Final Environmental Assessment

Installation and Rehabilitation of Stream Gages on the San Joaquin River, Fresno, Madera, Merced and Stanislaus Counties, California

EA-07-130

APPENDIX A
RESPONSE TO COMMENTS

Figure 15: Installation schematic for WaterLog H350XL/H355 gas bubbler/data logger, GOES satellite transmitter (H-222DASE) and YSI 600R Sonde water quality sensor at the Connector Channel Station Site

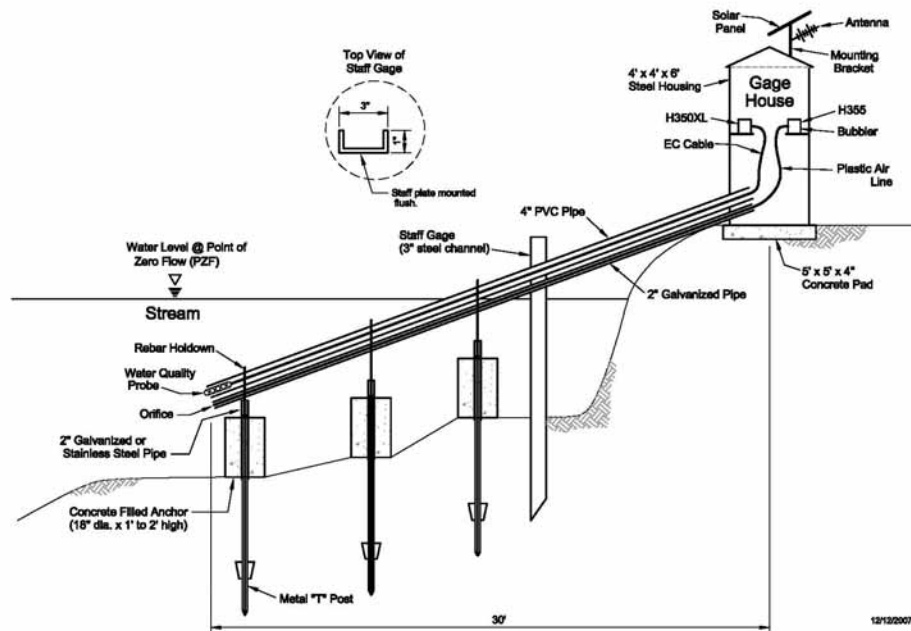
7. Page 22, the first full paragraph after the legend under Figure 15, the fourth sentence indicates that Water Resource Technicians will dig out the space for the pad by hand. A five foot by five foot by two foot hole is a lot to dig out by hand. If you are going have to bring a crane in anyway in order to set the gage house on its concrete slab, why not bring in a back hoe to dig our your hole for the concrete slab?

7. Comment noted.
8. See the newly added Section 2.2.2 Site Access and Entry.
9. See the newly added Section 2.2.2 Site Access and Entry.
10. The Harmon Brothers water right is a Fresno River diversion.
